Technical Information Sheet

R215 / R225 water pumps

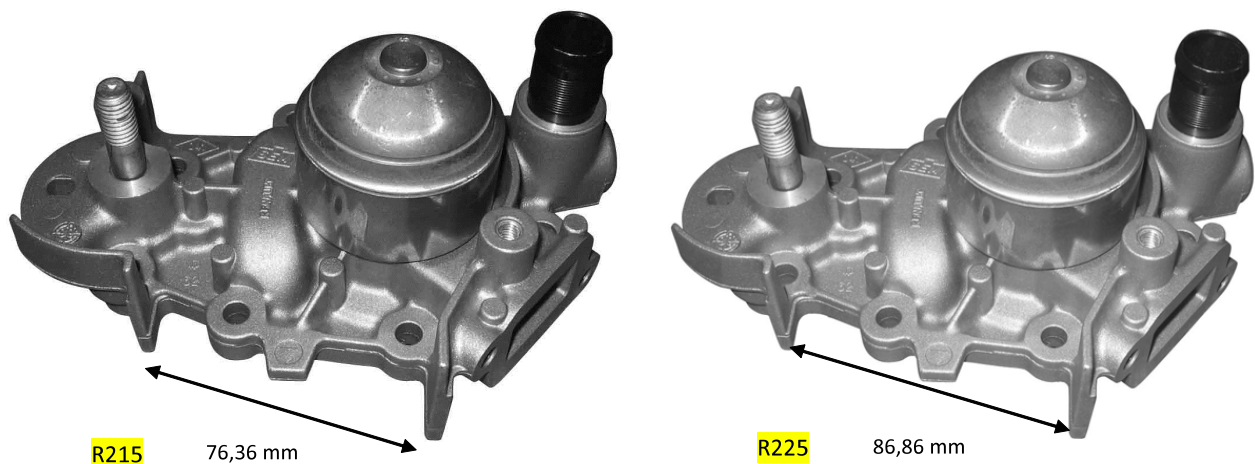
1. Dolz manufactures the R215 water pump exactly to OE 8200088663 - 820088660
2. This reference is very similar to R225 which corresponds to OE 8200266947. R225 can replace R215 if the cover which houses the timing belt is changed.

If your client can't fix the R215 because it knocks at some point, this is due to a wrong fitting, probably a R215 water pump in one of the R225's applications, and that's impossible.

OES has replaced one of the pumps for the other one, thus they suppress the R215 reference and use R225 water pump for all applications. Dolz will continue supplying this two references with the plastic cover, to avoid changes and increasing price in the repair.

NOTE: This two water pumps, and also the original Renault ones, have the holes to fix the plastic timing cover made without thread because these holes must be fixed with 2 self-tapping screws. This method ensures the correct fastening of the cover against engine vibrations.
